Project	IEEE 802.16 Broadband Wireless Access Working Group < http://ieee802.org/16 >	
Title	Harmonized Comments on the Channel Models in IEEE 802.16j-06/013	
Date Submitted	2006-09-28	
Source(s)	<p>Wen Tong, wentong@nortel.com Nortel 3500 Carling Avenue Ottawa, On, K2H 8E9 Canada</p> <p>Peter Wang, peter.wang@nokia.com Nokia 6000 connection drive Irving, Texas</p> <p>I-Kang Fu, IKFu@itri.org.tw National Chiao Tung University / Industrial Technology Research Institute 1001 Ta Hsueh Road, Hsinchu , Taiwan 300, ROC</p>	<p>David Chen , david.t.chen@motorola.com Tetsu Ikeda, Tetsu.Ikeda@motorola.com Motorola Inc 1441 W. Shure Drive, Arlington Heights, IL 60004 USA</p> <p>Jun Bae Ahn, jbahn@st.co.kr SOLiD Technologies 10th Fl., IT Venture Tower East Wing, 78 Garak-Dong, Dongpa-Gu, Seoul, 138- 803 Korea.</p> <p>Changyoon Oh, changyoon.oh@samsung.com Samsung Electronic 416 Maetan-3 dong, Yeongtong-gu Suwon-si, Gyenggi-do, Korea</p>

Re:	Response to the call for comments on IEEE 802.16j-06/013	
Abstract	This contribution captures the harmonization results during the IEEE session#45 Relay TG meeting	
Purpose	Proposes the harmonized comments and corresponding change request on the channel mo

Figure 2 RS-RS LOS link (ART to ART)

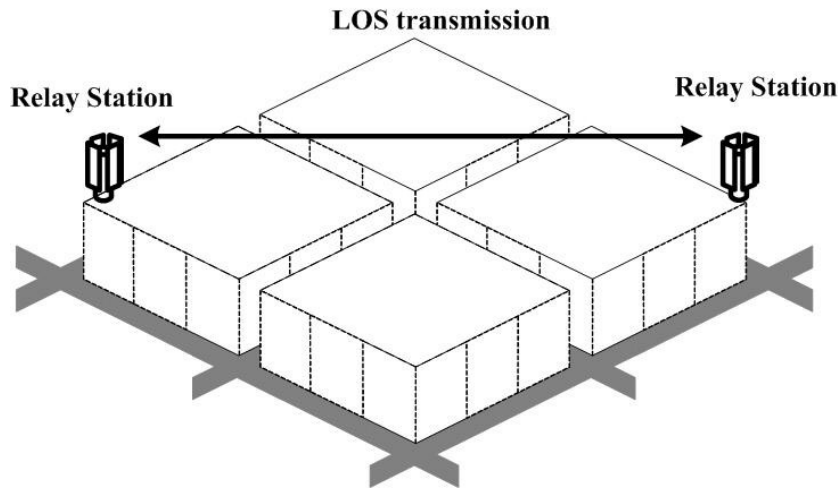
(Editor's note: Figure3 is moved to following location)

Figure 3 BS-RS NLOS (ART to BRT)

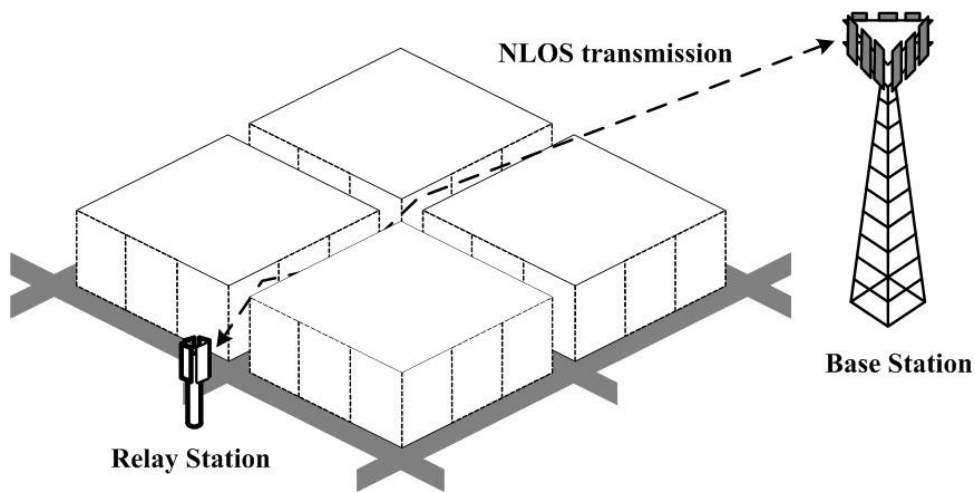
This scenario is shown illustrated in Figure 3, where in this case the BS antenna is mounted above the rooftops and the relay antenna is mounted below the rooftop (BRT).

Figure 8 The alternative model for RS-MS NLOS scenario

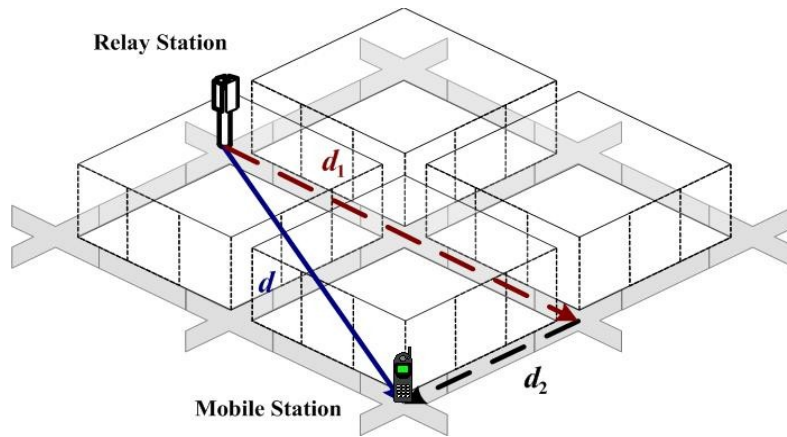
For ~~this Type-F NLOS~~ scenario, the alternative **WINNER** path-loss model can be used:

$$PL = 65 + 0.096 \cdot d_1 + (28 - 0.024 \cdot d_1) \cdot \log_{10}(d_2) \text{ dB} \text{ for } 10\text{m} < d_1 < 550\text{m} \text{ and } w/2 < d_2 < 450\text{m}$$

where d_1 is the distance along the main street in meter, ~~which is valid from 10m to 550m~~. d_2 is the distance for perpendicular street, ~~which is valid from $w/2$ m to 450m~~. w is the street width, and the carrier frequency is 5 GHz
